City of Phoenix

Staff Report: PHO-1-20—Z-62-02-7(8)

<u>APPLICATION:</u>	PHO-1-20—Z-62-02-7(8)
<u>APPLICANT:</u>	Ward Development
<u>REPRESENTATIVE:</u>	Alan Beaudoin, Norris Design
<u>OWNER:</u>	Rodney & Donna Kleck Family Trust Agreement
<u>LOCATION:</u>	Northeast corner of 59th Avenue and Dobbins Road
<u>REQUEST:</u>	<ol style="list-style-type: none">1) Modification of Stipulation 1 regarding general conformance with the site plan dated August 20, 2002.2) Planning Hearing Officer review and approval of site plan and elevations per Stipulation 3.3) Deletion of Stipulation 16 regarding a shade protected walkway along building walls with customer entrances.4) Modification of Stipulation 23 regarding canopy height.5) Presentation of commercial development plans to the Laveen Village Planning Committee for comment per Stipulation 29.6) Technical corrections to Stipulations 8, 11, 14, 15, and 22.

FRONT ELEVATION (DOBBINS ROAD)

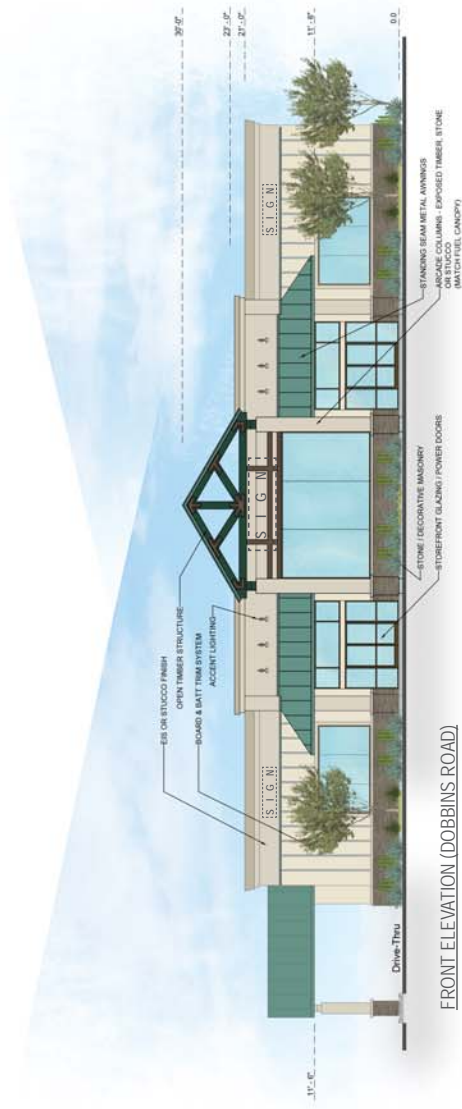
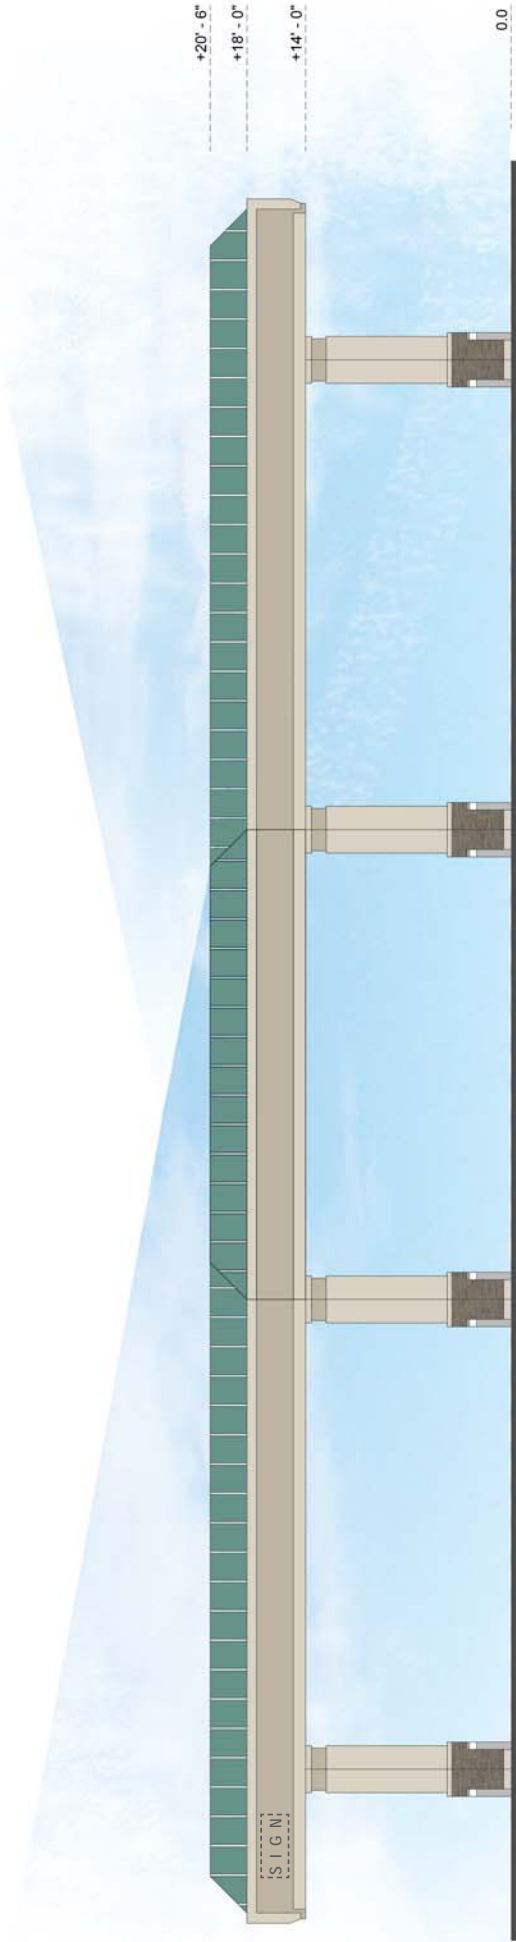
The applicant requested modification of Stipulation 23, regarding canopy height. The applicant stated that the requested increase from 16 feet to 18 feet maximum canopy height will allow for an enhanced 42-inch fascia treatment. This will allow for a typical steel canopy structure design with adequate opportunity for corporate branding

requirements. The first elevations that the applicant submitted were date stamped May 28, 2020. During the PHO hearing, the applicant explained that conceptual elevations for the fuel canopy were revised in order to include a new mansard-roof style and provide enhanced rural character. After the PHO hearing, the applicant submitted updated elevations which were date stamped July 20, 2020 and were presented at the PHO hearing.

10. The applicant's request for modification of existing Stipulation 23 is recommended for approval. The modification of maximum height of the canopy from 16 to 18 feet is a modest increase and remains significantly lower than the 30-foot maximum height permitted by the underlying zoning. This height is also compatible with the maximum 15 feet building height depicted on the conceptual site plan. Finally, the request does not alter the existing regulation of 14 feet maximum height to the underside of the canopy where recessed lighting may be located. Therefore, the modification will not increase any potential negative impact of lighting on nearby or adjacent properties.

However, note that the Zoning Ordinance contains a design presumption in Section 507 Tab A II.D.2. stating that canopy heights measured from finished grade to the lowest point of canopy fascia should not exceed 14 feet in height and that overall canopy height should not exceed 16 feet. This design presumption will need to be overcome during the plan review process regardless of the rezoning stipulation given that it is more restrictive.

NORTHEAST CORNER OF 59TH AVENUE AND DOBBINS ROAD.
2.		THE COMMERCIAL DEVELOPMENT SHALL BE IN GENERAL CONFORMANCE WITH THE BUILDING, FUEL CANOPY, AND SCREEN WALL ELEVATIONS DATE STAMPED JULY 20, 2020, AS MODIFIED BY THE FOLLOWING STIPULATIONS AND APPROVED BY THE PLANNING AND DEVELOPMENT DEPARTMENT.
